# Access Compliance Report

## Public Rights-of-Way

Intersection ID: 24374	Main Street: BEVERLY_CREST_BV	Cross Street: HUGH_FOREST_RD	Location: W
ADA ID: A0FD84D55C6D	Ramp Type: Perp	Initial Pass/Fail: Fail	Overall Compliance: No
Severity Score: 25			
Codes/Mitigation Info/Possible Solution		Field Measurements/Component Compliance

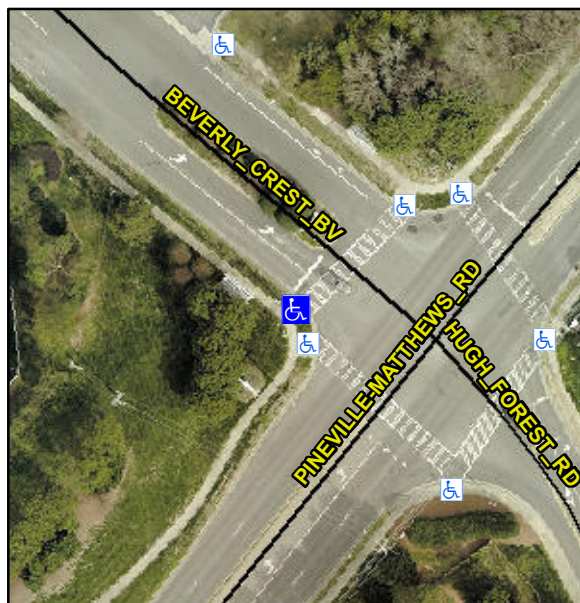
**Not Found, R304.5.3**

Compliance	Description	Data	Compliance	Description	Data
N/A	Ramp Length (in)	94.0	Yes	Ramp Slope (%)	8.1
Yes	Ramp Width (in)	72.0	No	Ramp XSlope (%)	7.6
N/A	Flare Type LT	N/A	N/A	Flare Type RT	N/A
N/A	Flare Slope LT (%)	N/A	N/A	Flare Slope RT (%)	N/A
N/A	Flare Traversable LT?	N/A	N/A	Flare Traversable RT?	N/A
N/A	Landing Length (in)	N/A	N/A	DWS Provided?	N/A
N/A	Landing Width (in)	N/A	N/A	DWS Contrast?	N/A
N/A	Landing Slope (%)	N/A	N/A	DWS Length (in)	N/A
N/A	Landing X Slope (%)	N/A	N/A	DWS Full Width?	N/A
N/A	Landing Curb? (Y/N)	N/A	N/A	DWS Offset (in)	N/A
N/A	Shared Landing?	N/A			
N/A	Gutter Ponding?	N/A	N/A	Gutter Slope (%)	N/A
N/A	Gutter Lip Ht (in)	N/A	N/A	Gutter X Slope (%)	N/A
N/A	Painted X Walk1?	Yes	N/A	Painted X Walk2?	N/A
	X Walk 1 Direction	To NE		X Walk 2 Direction	N/A
N/A	X Walk 1 Width (in)	112.0	N/A	X Walk 2 Width (in)	N/A
	X Walk 1 Slope (%)	1.2		X Walk 2 Slope (%)	N/A
	X Walk 1 X Slope (%)	6.1		X Walk 2 X Slope (%)	N/A

**Remove & Replace Entire Ramp.**
